## ADDENDUM

**PROJECT:** University of South Dakota  
Patterson Hall  
Mechanical / Electrical Infrastructure Upgrades  
Vermillion, South Dakota

AD-3

**DATE ISSUED:** Monday, February 2, 2015

Drawing #  
**A-403.1**

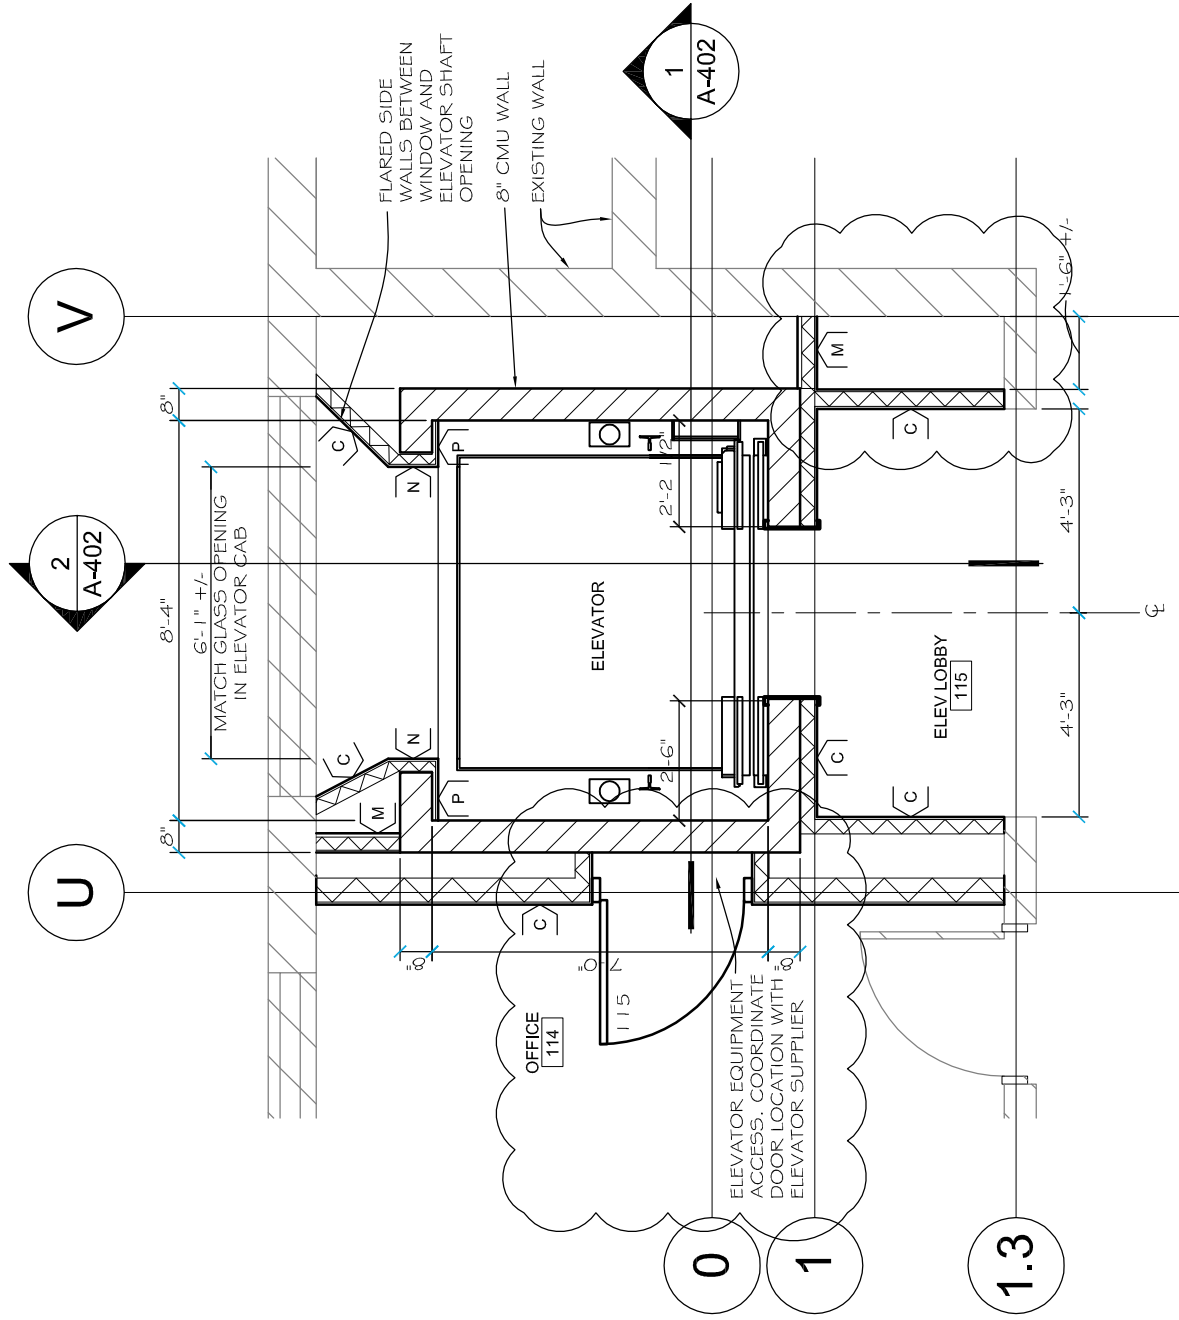
In reference to Sheet A-403 and attached supplemental drawings A-403.1, change Enlarged Floor Plan 2 to reflect the attached supplemental drawings A-403.1. This drawing shall also update the referenced area First Floor Plan - Area B on Sheet A-106. Demolition for the new door location shall be required on Sheet A-101, Partial First Floor Demolition Plan - Area B. As a matter of clarification, elevator equipment controls/machine room shall be installed in the shaft wall behind the door and shall be completely coordinated with elevator manufacturers requirements.

M-104.1

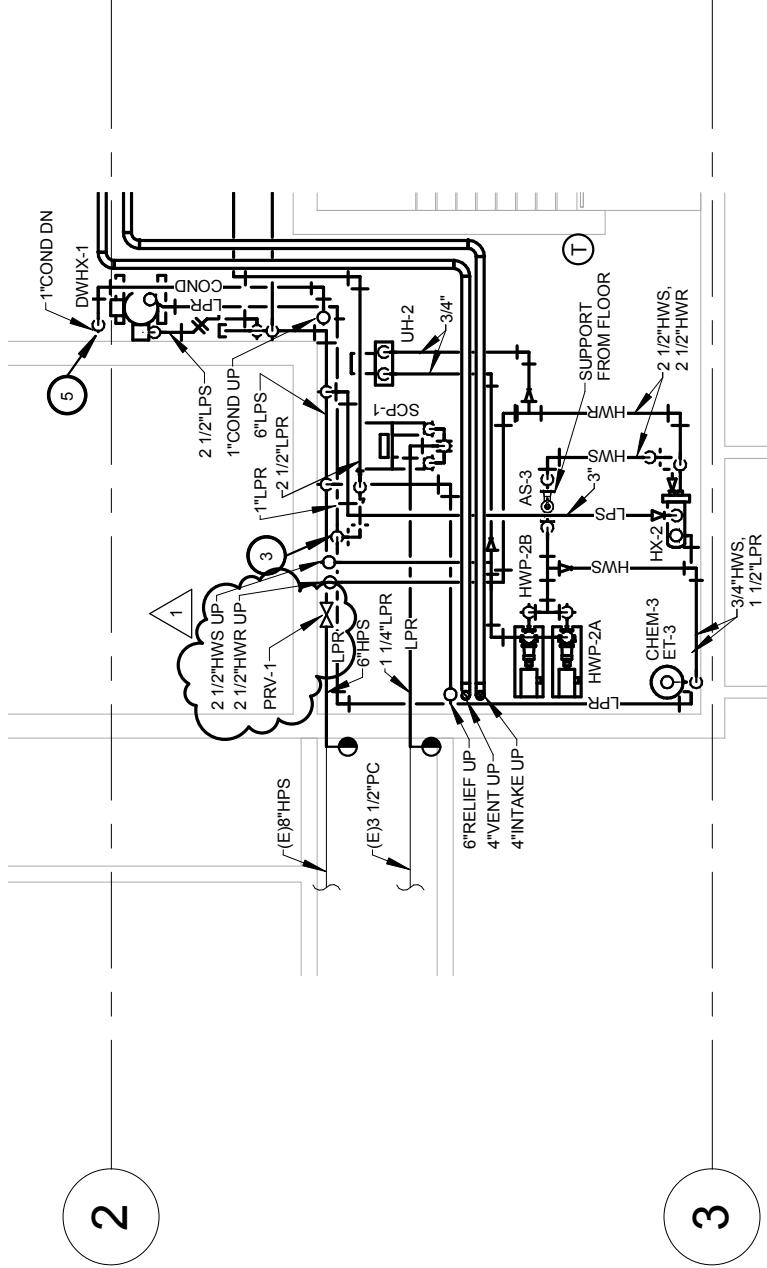
In reference to Sheet M-104, refer to attached drawing M-104.1 for location of the steam pressure reducing valve.

M-105.3

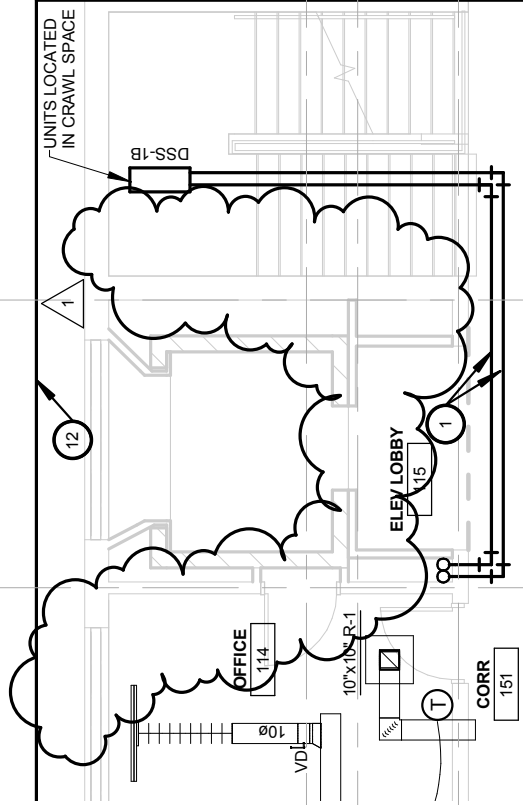
In reference to Sheet M-105, refer to attached drawing M-105.3 for deletion of the ductless split system DSS-2A/B.
